TECHNICAL BULLETIN

No: SB034-SB036

Issue: 4

SERVICE ACTION: Vehicle Enhancement Program

Figure 2

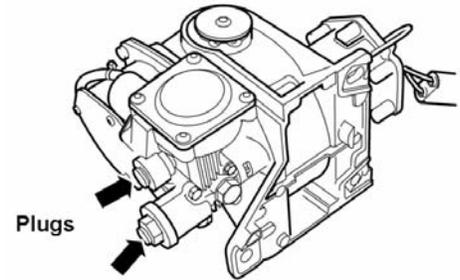
4. Install plugs to the open connections of the inlet and outlet pipes of the compressor being inspected and clean the compressor assembly. (Figure 2)
5. Undo and remove the delivery valve-retaining plug: (Figure 3)

Figure 3

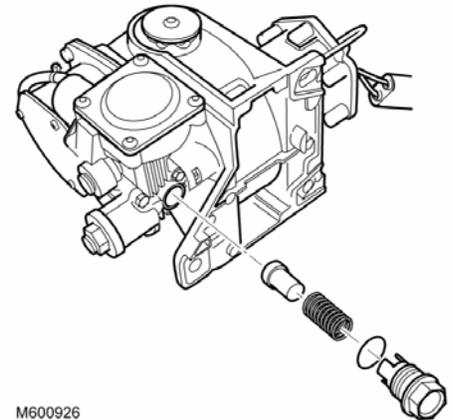
- Remove and discard the retaining plug O-ring seal.
 - Remove the return spring and the delivery valve and discard the spring.
 - Inspect the delivery valve for damage (Figure 4)

Figure 4

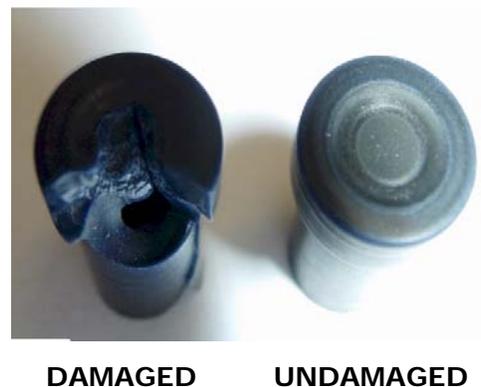
- If the delivery valve is damaged (left image in Figure 4) replace the air compressor with a new unit following GTR section 60.50.10 procedures.
 - If the delivery valve is **not** damaged, (right image in Figure 4) perform the Compressor Repair Procedure that follows.

Figure 5

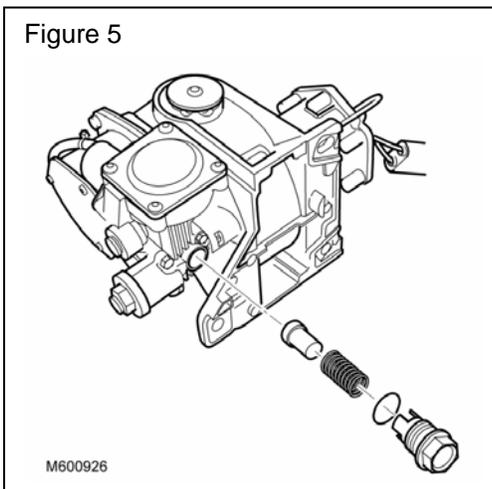
1. Install new delivery valve assembly from kit JPO500010 as follows: (Figure 5)
 - Install a new O-ring seal to the delivery valve-retaining plug.
 - Assemble the new spring and new delivery valve.

- Install new spring and new delivery valve into the compressor.
 - Tighten the delivery valve-retaining plug to **12.5Nm (9.2 lbf.ft)**.
2. Undo, remove and discard two diagonally opposed exhaust valve plunger cover securing screws to permit puller installation. (Figure 6)

Figure 7

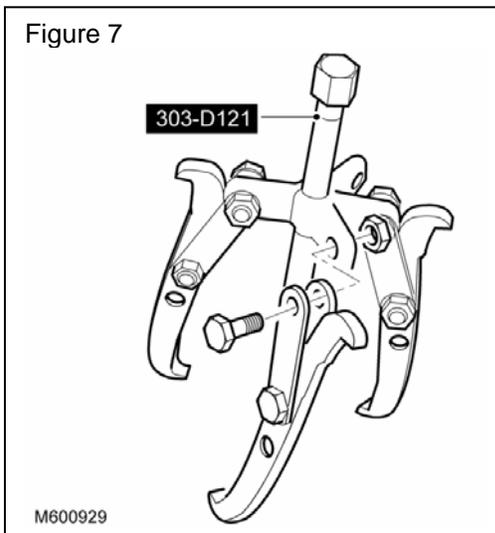
3. Configure special tool 303-D121 to two-leg mode or alternatively, use a suitable two-leg puller. (Figure 7)
4. Install and align special tool 303-D121 and the protective button from tool 303-588 to the exhaust valve plunger cover. (Figure 8)

Figure 8

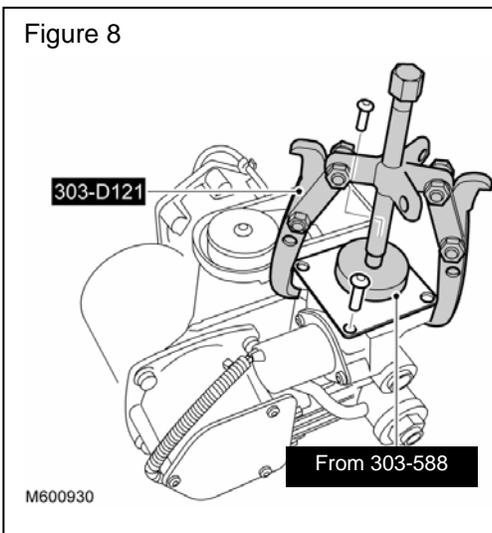
5. Hand tighten the tool only enough to hold the plate in position.
6. Undo, remove and discard the two remaining plunger cover securing screws. (Figure 8)

Figure 9

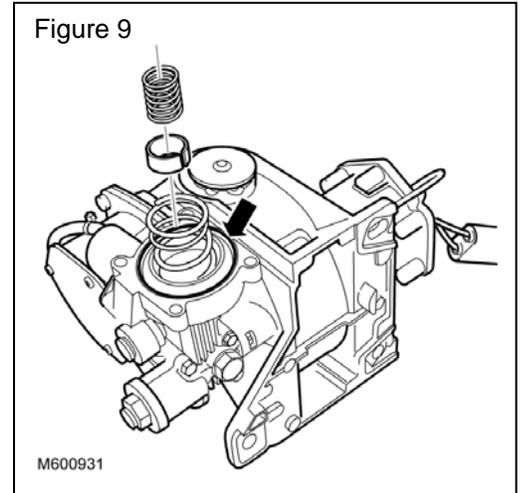
9. Remove the cover when spring tension is relaxed.
10. Remove and discard the orange O-ring seal. (Arrowed in Figure 9)
11. Install the new inner spring and spacer from kit JPO500010 at the center of the original outer spring. (Figure 9)
12. Install and fully seat the new orange O-ring seal from kit JPO500010.
13. Install and align the plunger cover.

Figure 10

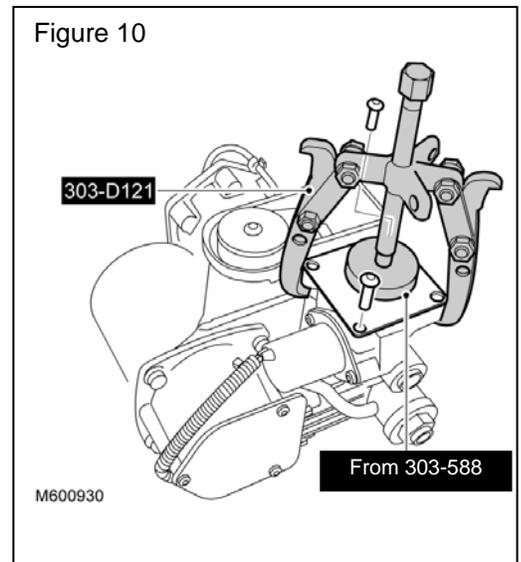
14. Install the puller and the "button" special tool and carefully tighten the puller to compress the springs to a snug seated condition. (Figure 10)

15. Install and finger tighten the two exposed cover screws to secure the cover. (Figure 10)
16. Undo and remove special tool 303-D121.
17. Install the two remaining new plunger cover screws. (Figure 11)
18. Tighten the final two screws to **5Nm (3.6 lbf.ft)**.
19. Tighten the first two screws installed to **5Nm (3.6 lbf.ft)**.
20. Using a suitable paint marker, strike through the original part number on the compressor to identify that the unit has been repaired.
21. Refer to GTR section 60.50.10 and install the repaired compressor unit to the vehicle.

Figure 1

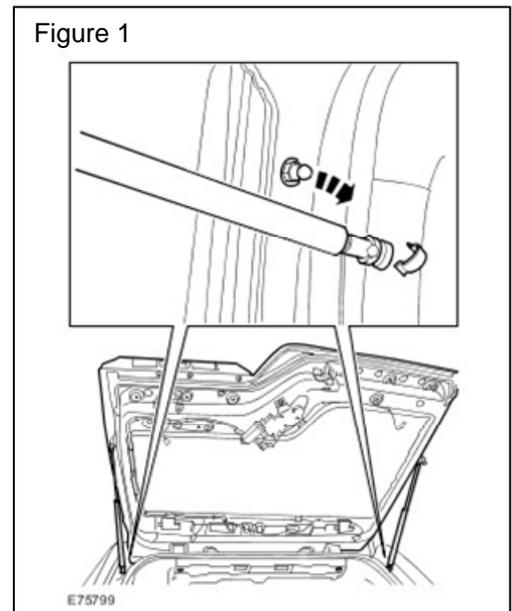
1. Release the upper tailgate support strut from the D-pillar ball stud. (Figure 1)
2. Remove the ball stud assembly from the body.
3. Apply liquid thread-lock (STC50552/Loctite 242) to the ball spigot thread.
4. Install the ball spigot.
5. Tighten to **23Nm (17 lbf.ft)**.
6. Install the upper tailgate support.

Figure 2

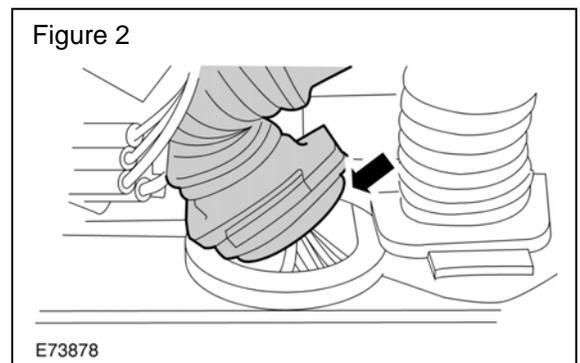
1. If the E-box grommet was determined to not be located correctly during the inspection above, perform the following:
 - Disconnect and remove the battery for access.
 - Install the grommet. (Figure 2)
 - Install the battery and connect battery leads.
2. Remove fender protection covers, and close the hood.
